TOWN OF KITTERY
PLANNING AND CODE DEPARTMENT
200 Rogers Road, Kittery, ME 03904
Telephone: 207-475-1305 Fax: 207-439-6806
kitteryme.org

NOTICE OF DECISION

PROPERTY OWNER AND APPLICANT:	Landmark Hill, LLC
MAILING ADDRESS:	PO BOX 81 Portsmouth, NH 03802
PROPERTY LOCATION:	518 U.S. Route
MAP LOT/ZONE:	MAP 67 LOT 2/ MU
APPLICATION:	MINOR MODIFICATION TO AN APRVD PLAN
DATE:	November 1, 2017

SITE/SUBDIVISION PLAN

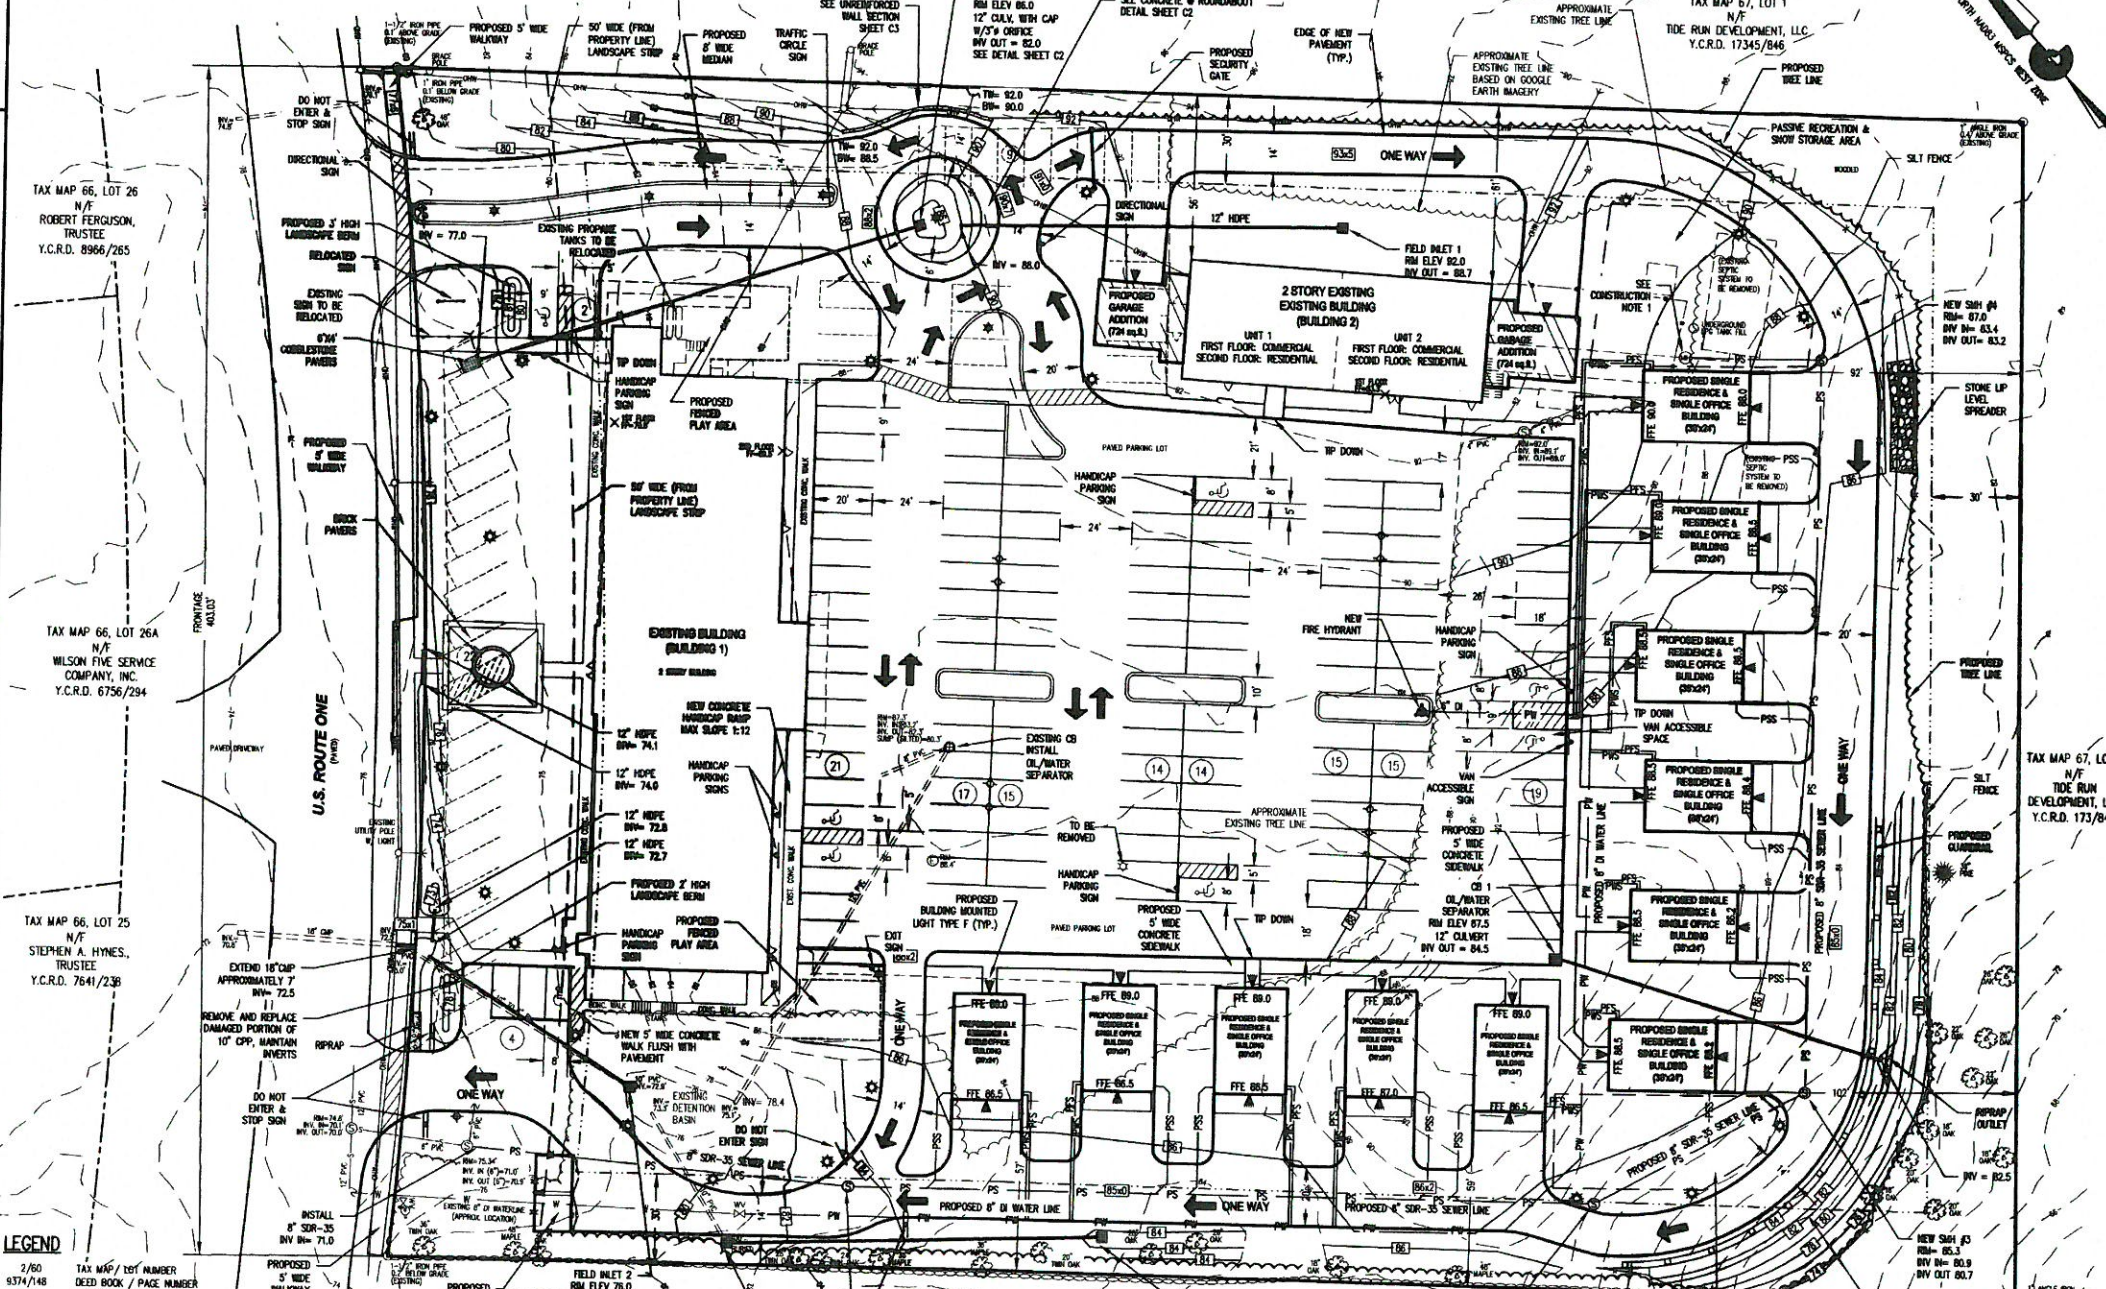
1) The Site and Subdivision plan was approved by the Planning Board on 6/8/2017 and recorded at the YCRD BK 390 PG 21. The approved plan includes parking closer to the front property line than the principle building (no. 1) as allowed per section 16.3.2.13.D.5. This parking is being proposed to be relocated slight to allow for the required construction details necessitated by the handicap parking. The following were on the approved plan and are proposed to be modified:

AMENDED SITE/SUBDIVISION PLAN
PROJECT NO: 16-309.00
C1
SHEET: 1 OF 3

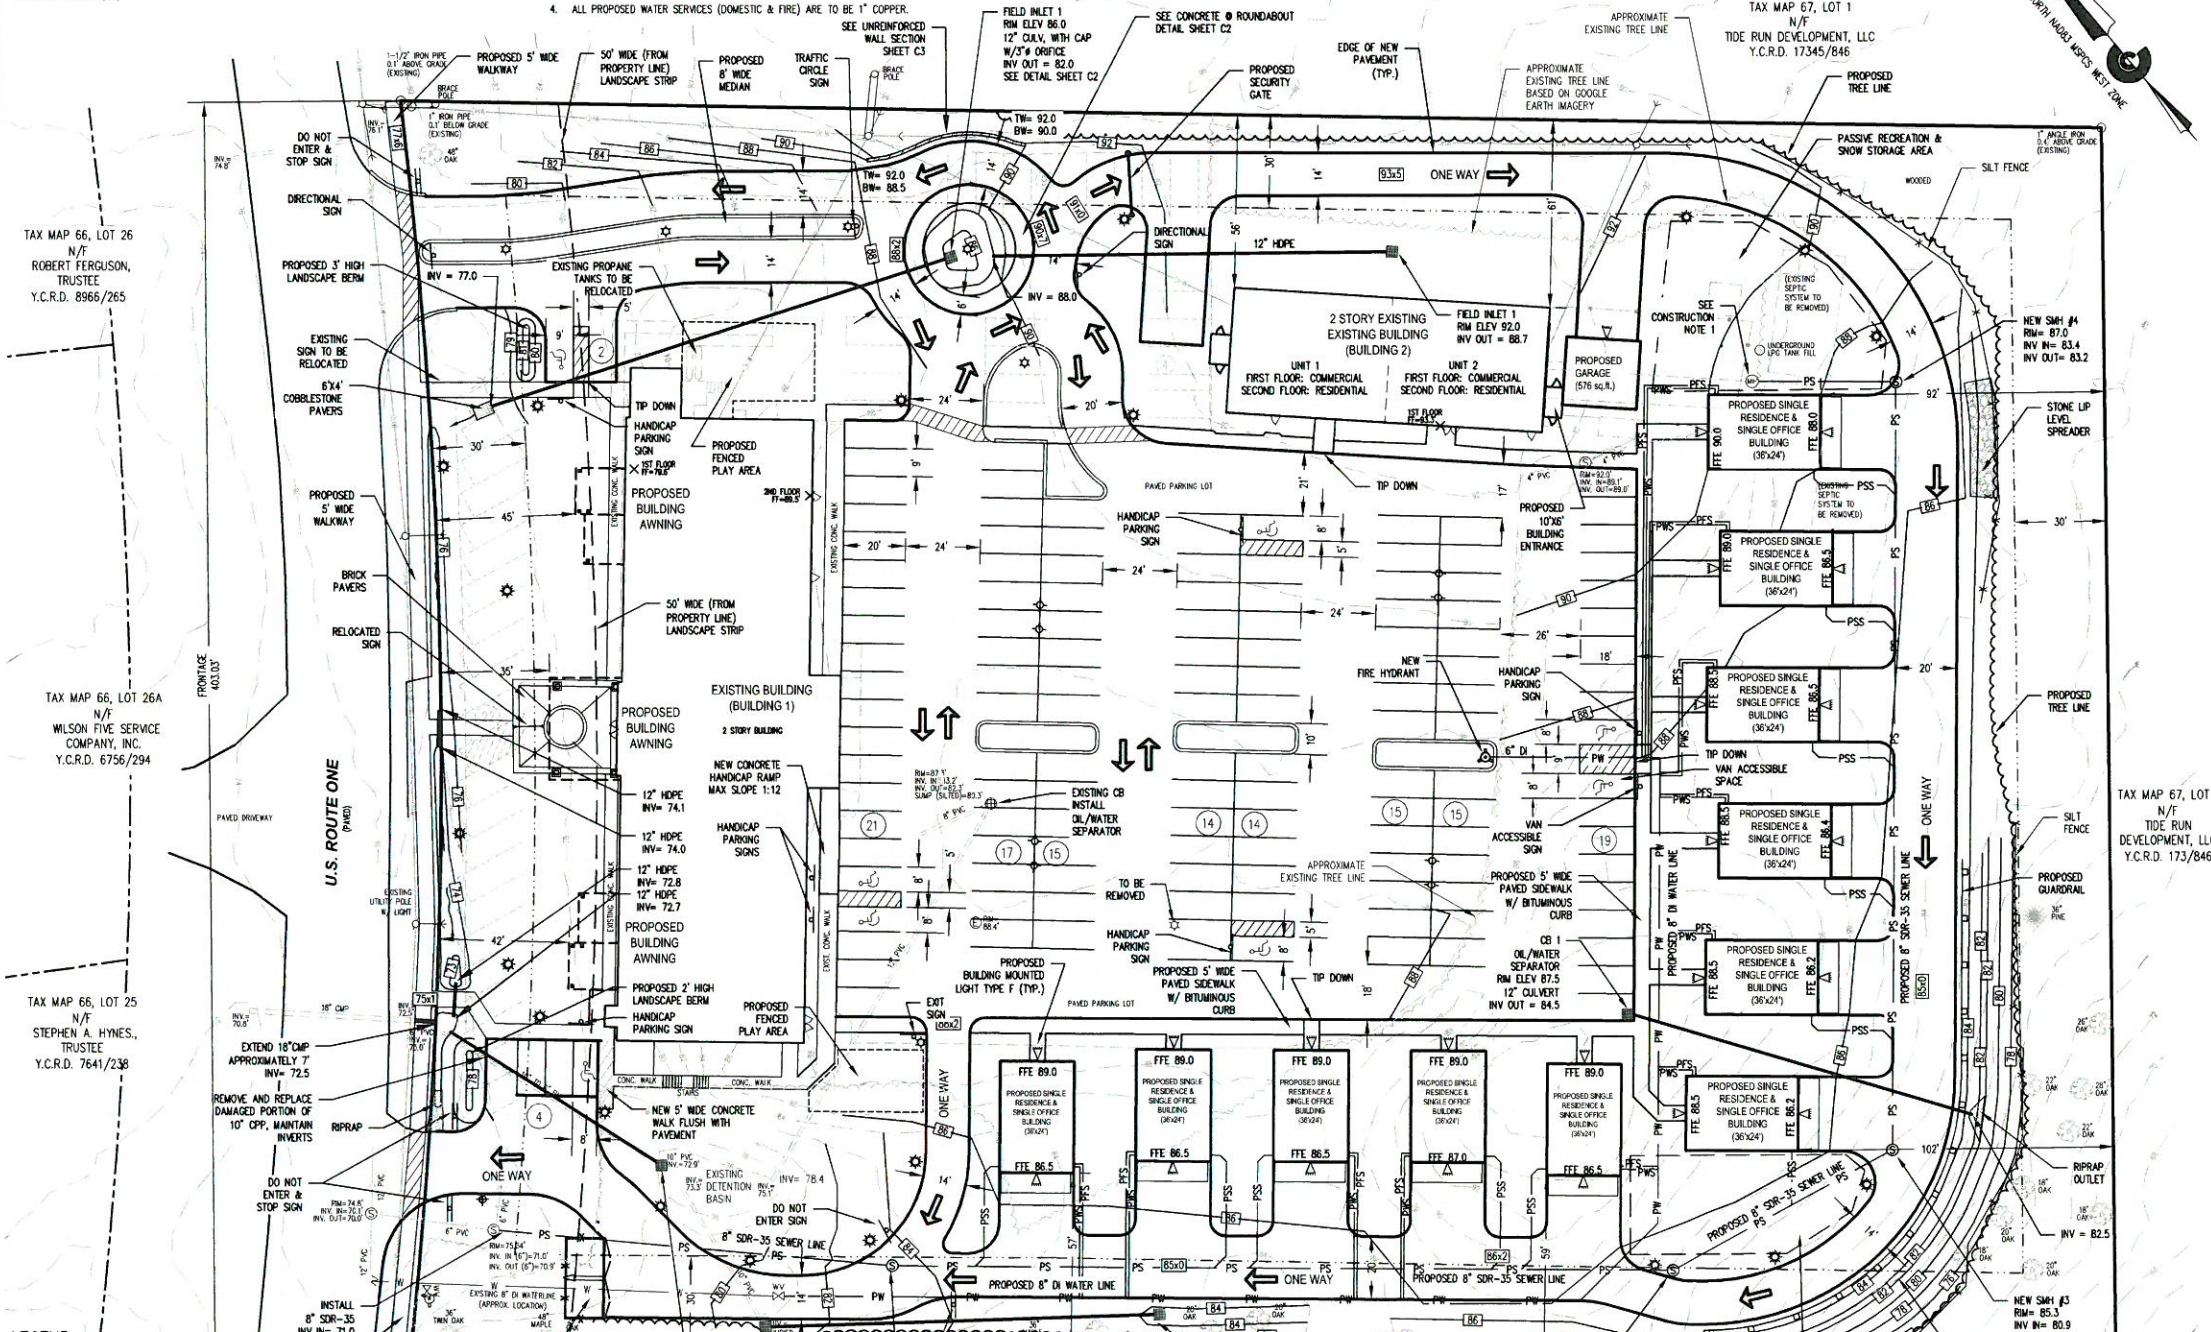
- a) On site concrete sidewalks with granite curbs changed to bituminous sidewalks and curbs

- b) Three new additions to the front of existing Building 1, no less than 30 feet from the front property line.
- c) The change in location of parking approved to either side of the principle building number 1 in the front yard to a location where the stalls are directly in front of the building.

- 1) Extend the proposed earth berms and plantings associated with the parking located in the front yard.
- 2) Revise the draft amended site/subdivision plan (9/28/17) to include the following:

- a. Add to the first sentence under Plan notes for *Amendment #1* “as approved by the Town Planner and CEO on 11/1/2017 per Town Code 16.10.9.3 *Modifications to an Approved Plan*”

- b. Add ‘ordained 7/14/2017’ after ‘zoning amendment’ under Plan notes for *Amendment #1*.
 - c. Replace the word ‘awning’ with ‘addition’ under Plan notes for “Amendment #1 and on the plan. Can denote that there is no ‘floor area’ associated with the additions.

- d. Add the word ‘proposed’ when describing ‘garage’ in note #3 under Plan notes for *Amendment #1*
 - e. Add the parking changes as described in exhibits provided by Tom Severino to the plan and to the Plan notes for *Amendment #1*.

- f. Depict on the plan an extension of the berms and planting to reflect the expanded area of parking in the front yard.
 - g. Add a note to the signature block “refer to Plan reference 1.”

- h. Add to plan note regarding the sidewalk in the Street ROW ‘(construction material to be approved by Dept. of Public Works)
 - i. Update Plan Note 9 as it relates to the proposed garage changes.
